T. W. Quigley
Environmental Project Leader
Sand Rock Mill
Minerals Department

Re: Conoco's Response to NRC Comments on Sand Rock Mill Project - NRC
Docket No. 40-8743

Comment No. 2

FIGURE A-1.49 DRAWDOWN DATA FOR PUMPING WELL 1814 (70 SAND)

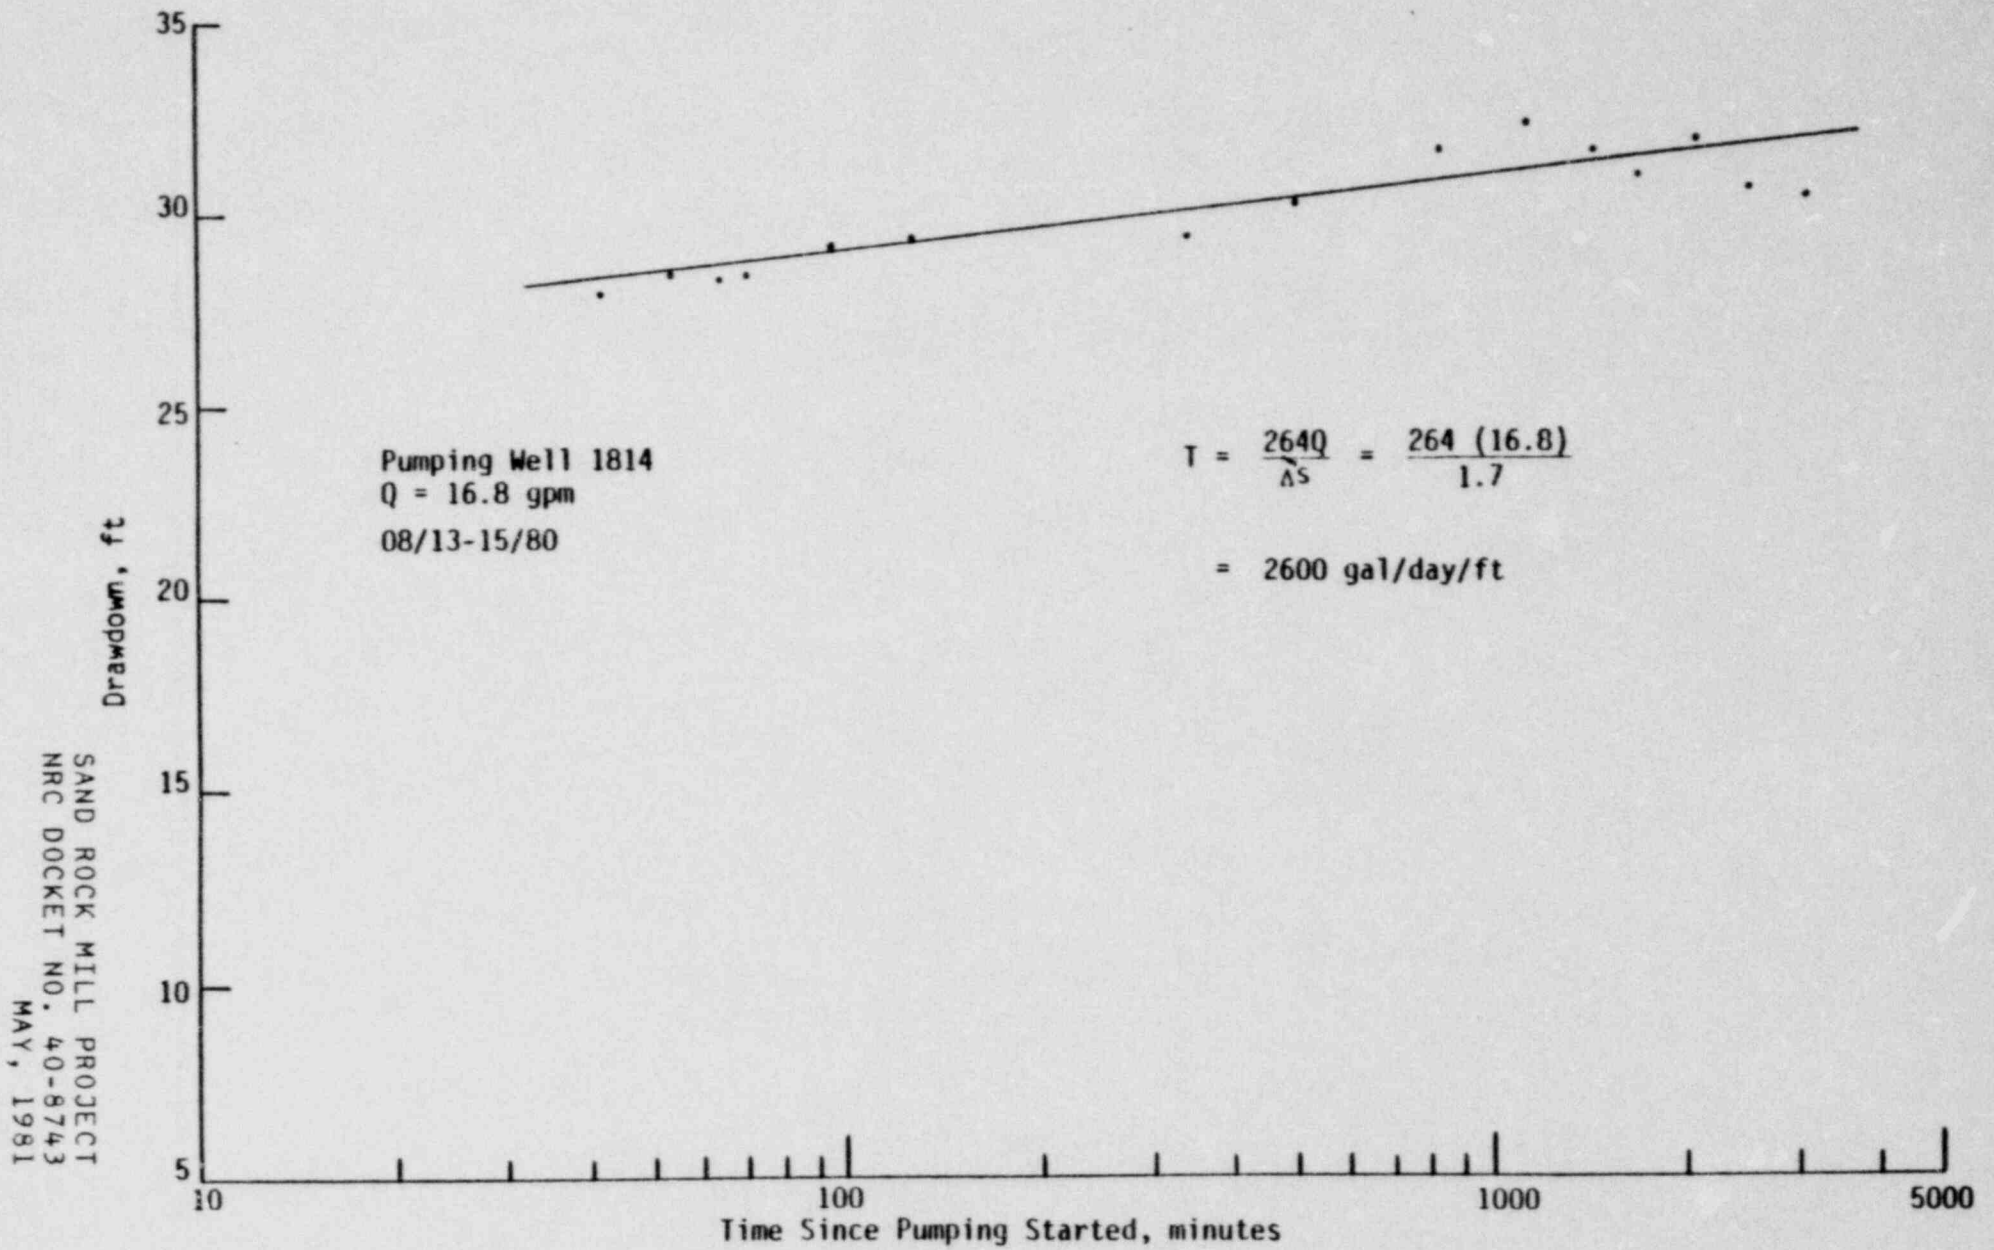
Provide the aquifer properties, groundwater flow direction, and groundwater quality data for the "68" sand. Is there hydraulic communication (1) between the "68" sand and the ore-bearing "70" sand? (2) between the "68" sand and the "60" sand? (Section 2.7.1)

The semi-log of the drawdown in the pumping well is given in Figure A-1.49. The fit of the straight line yields a transmissivity of 2600 gal/day/ft for the transmissivity of the 7C sand near well 1814. Streltsova's type curve for an anisotropic ratio (K_v/K_h) of 0.07 and storage ratio (S/S_y) of 8×10^{-2} matched the drawdown data in observation well 1815. Figure A-1.50 presents this match of the type curve to the drawdown data. Values of 5500 gal/day/ft, 6700 ft/yr and 470 ft/yr were calculated for the transmissivity, horizontal and vertical permeability, respectively. Storage values of 0.014 and 1.1×10^{-3} were computed from the type curve match for the specific yield and storage coefficient.

SAND ROCK MILL PROJECT
CAMPBELL COUNTY, WYOMING
50 MILE RADIUS
URANIUM OPERATIONS

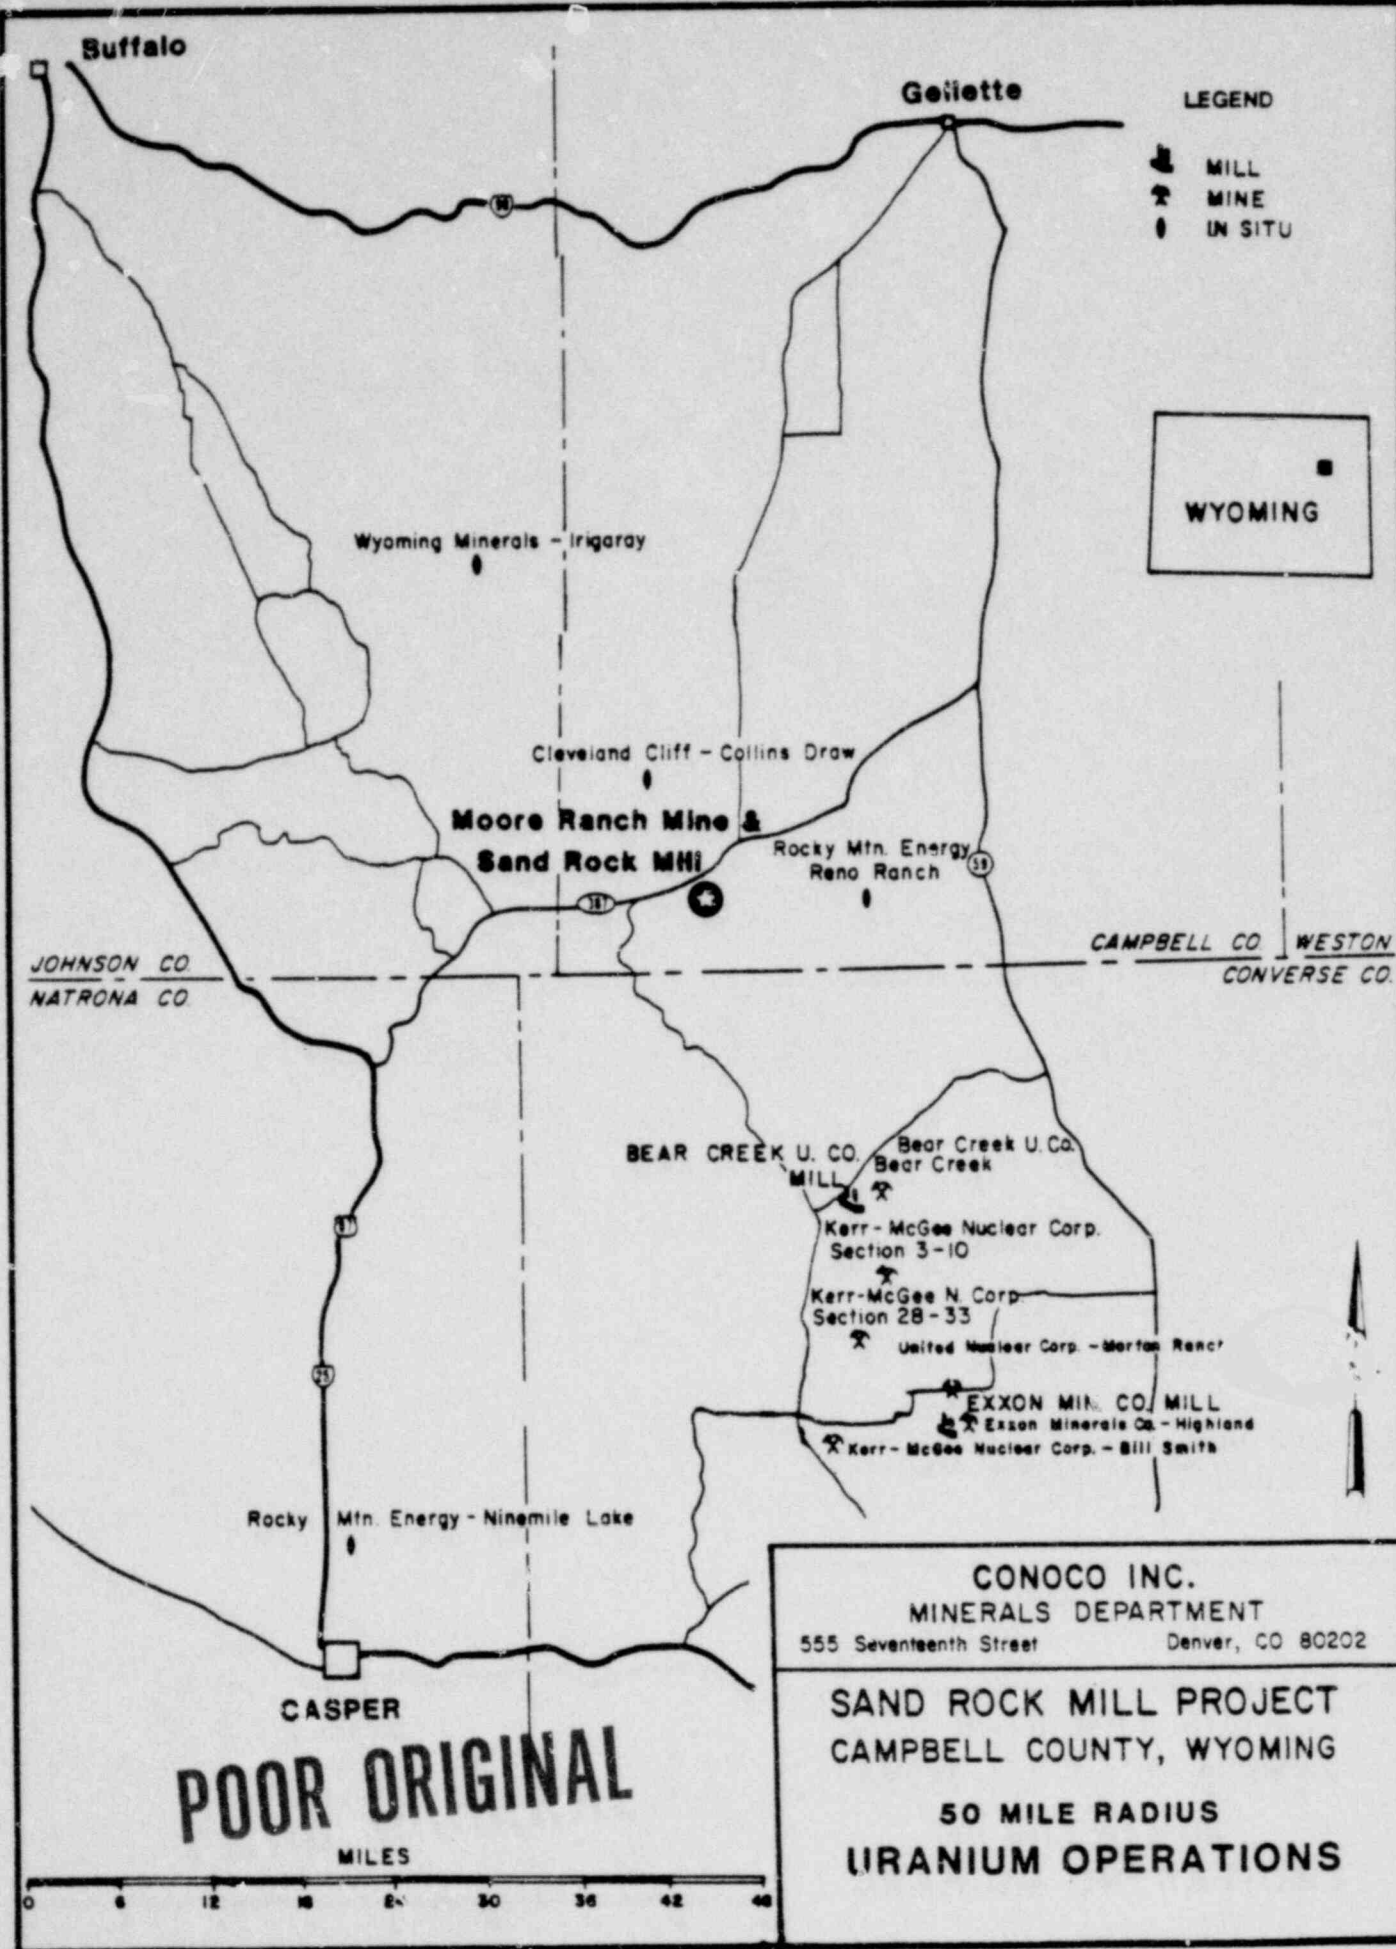
Provide a map indicating the locations of the uranium mills and mines within 50 miles of the project site. (p. 2-12)

Map is attached.

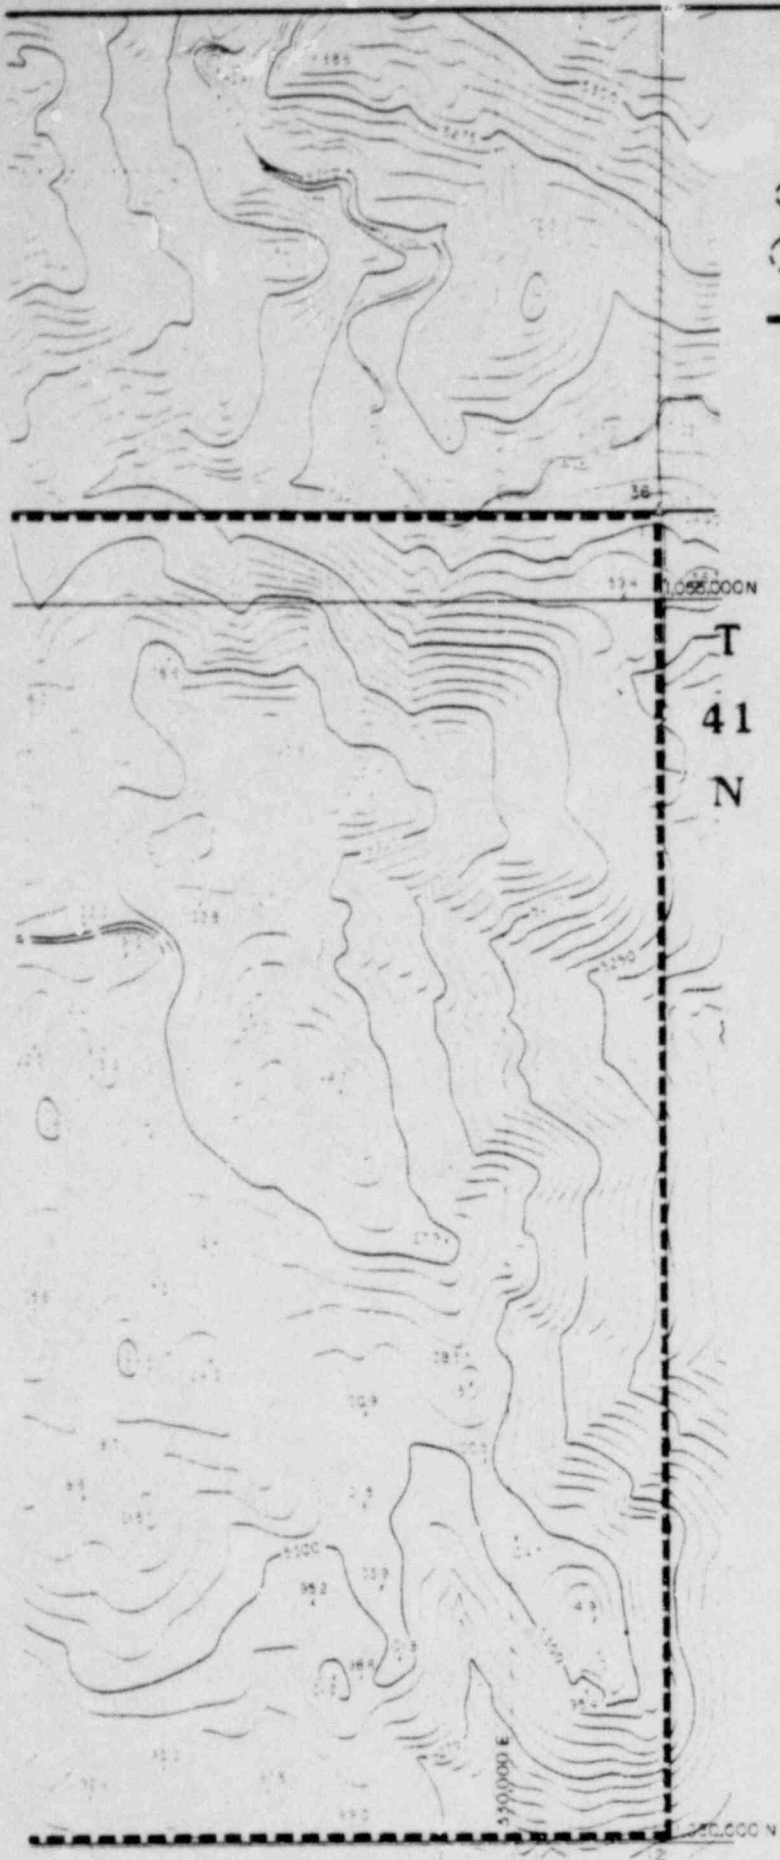
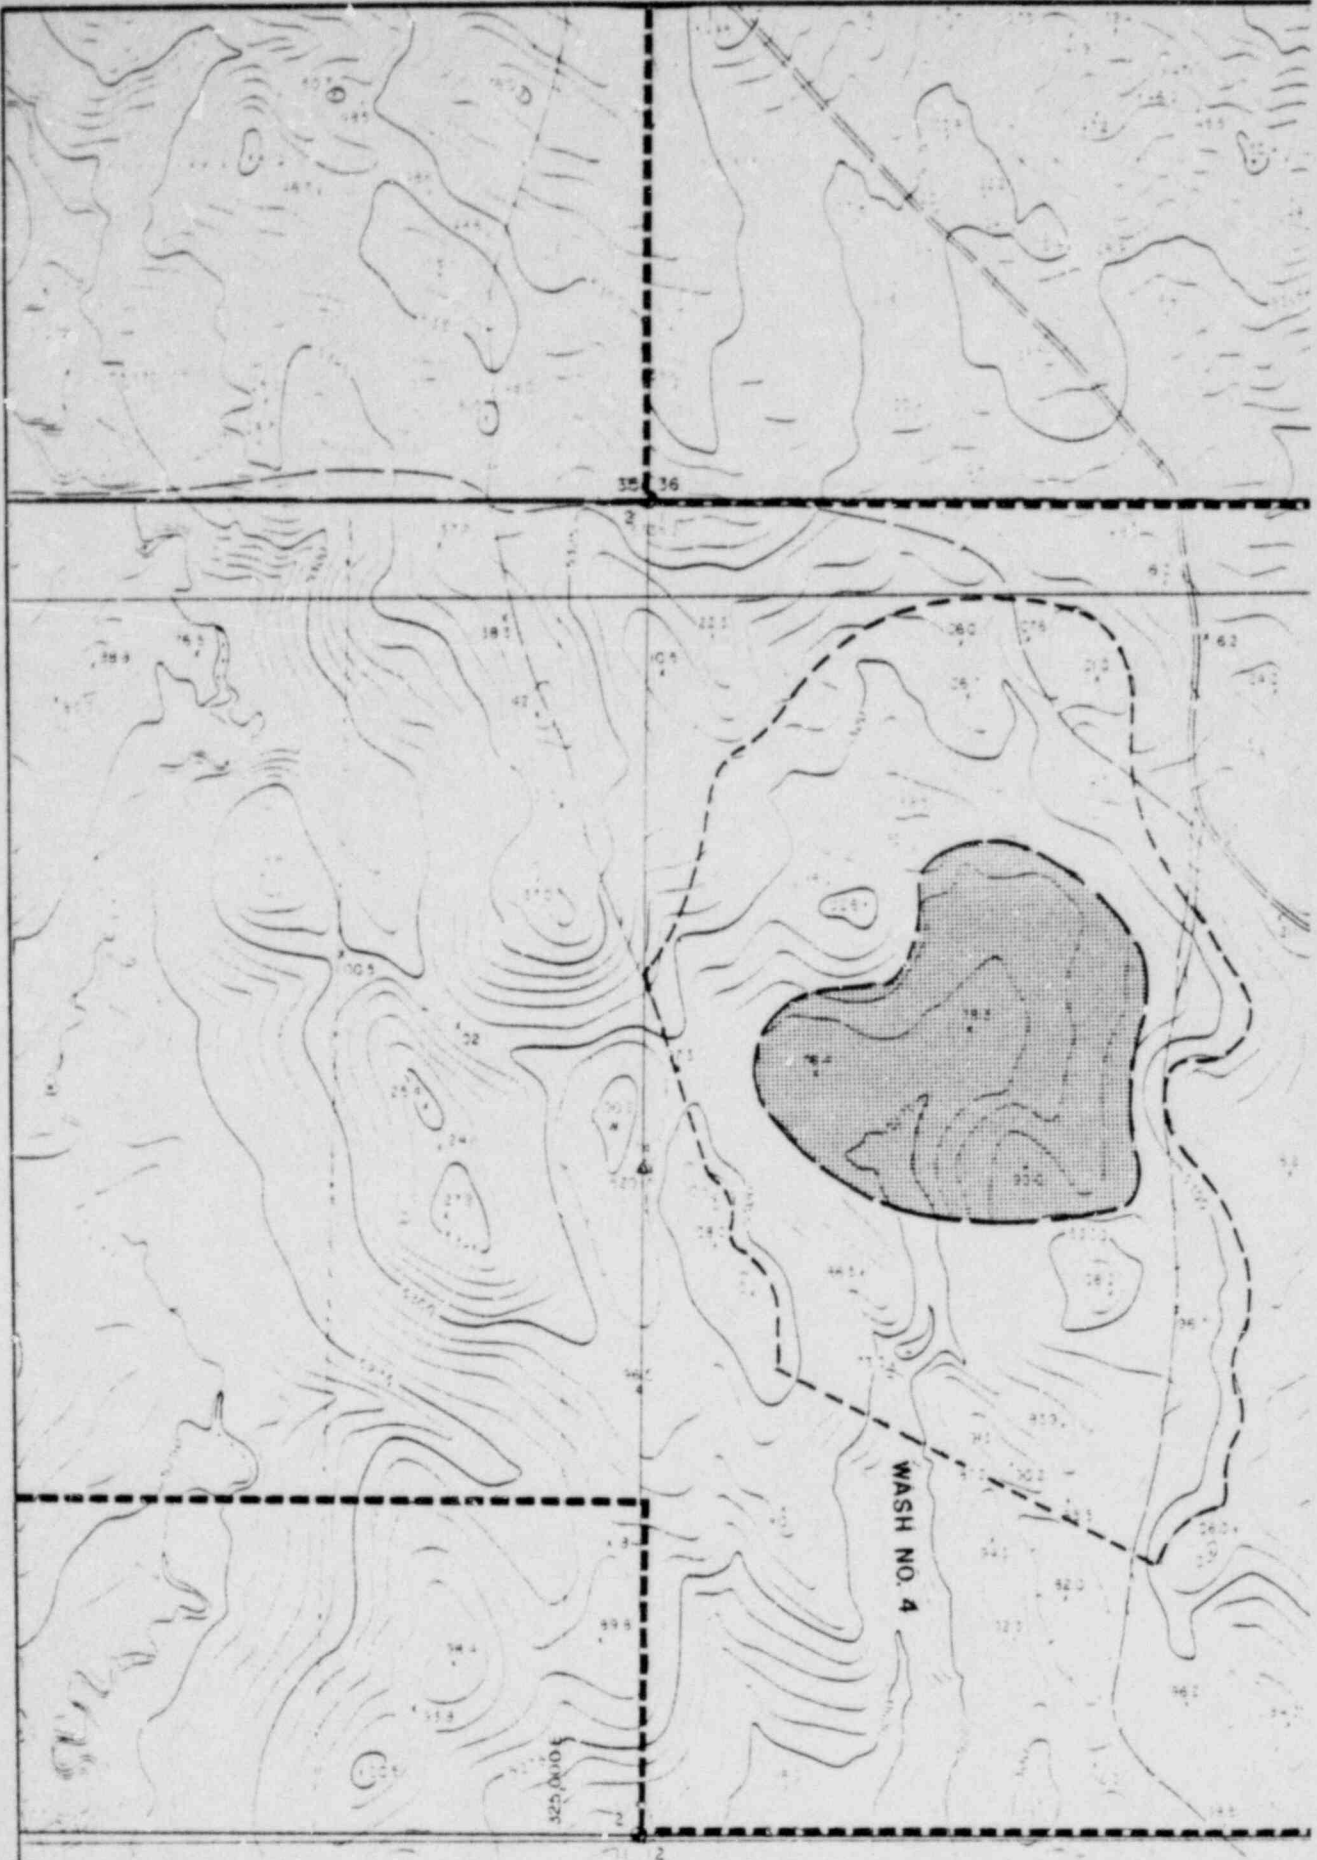
Provide a detailed analysis of potential for the occurrence of the black-footed ferret. Provide a map showing the exact location of the prairie dog town relative to the evaporation pond.

A map showing the prairie dog town and evaporation pond areas is attached.
